PUBLIC INTEREST REVIEW FOR GROUNDWATER APPLICATIONS

SUBJECT: Application G- 17832 Supersedes review of April 15, 2014
Date of Review(s)

A. GENERAL INFORMATION: Applicant's Name: Berrett Ranches, Inc. County: Malheur

Application G-17832, Berrett Ranches, Inc.

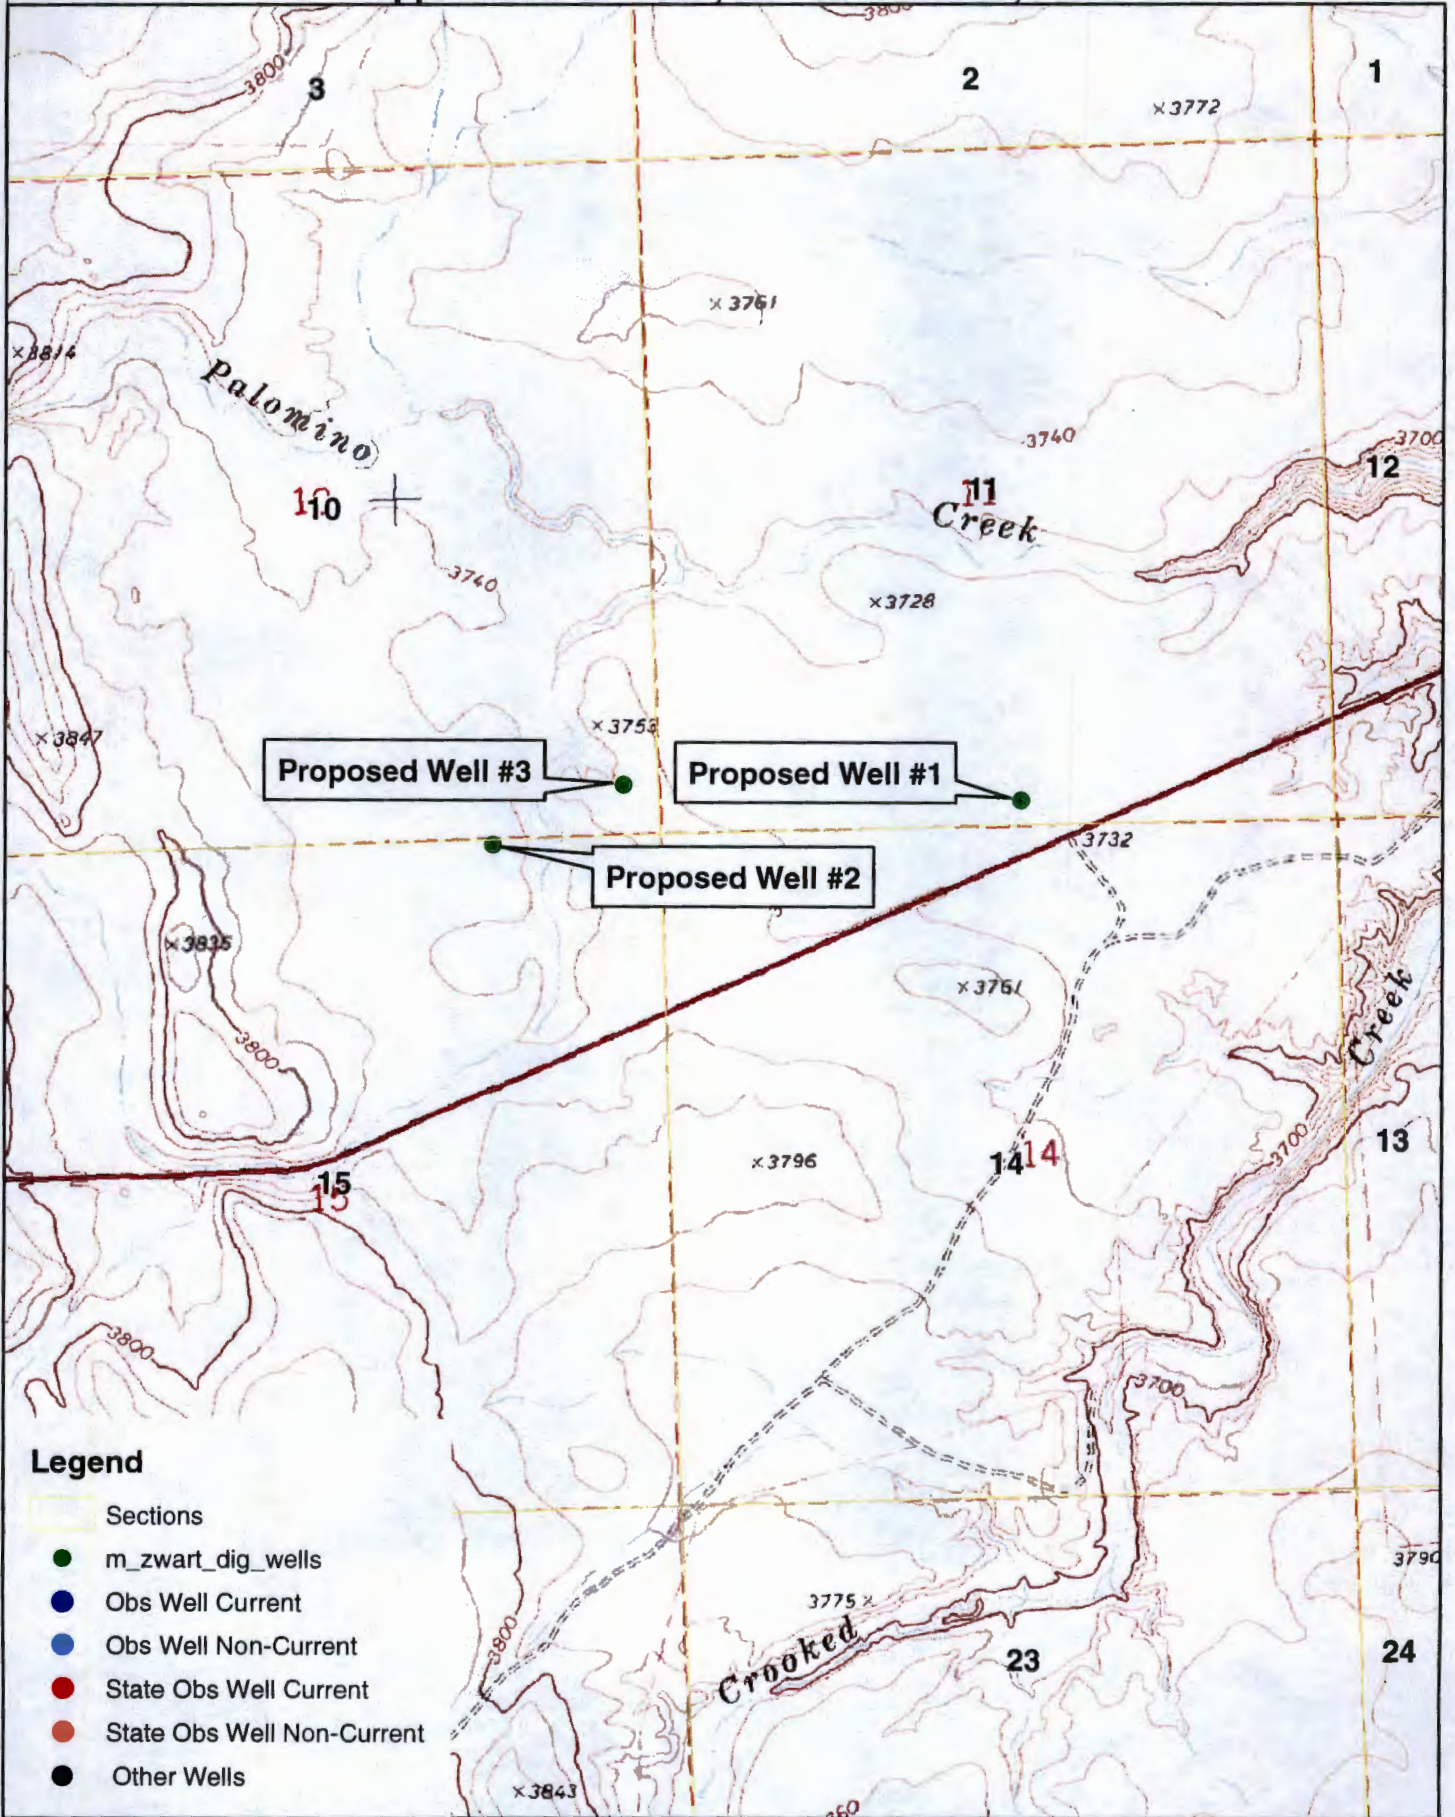
A4. **Comments:** Well 2 and 3 are transposed on the map versus their metes and bounds. The above metes and bounds reflect the map locations. There was no proposed construction information provided except for the depth.
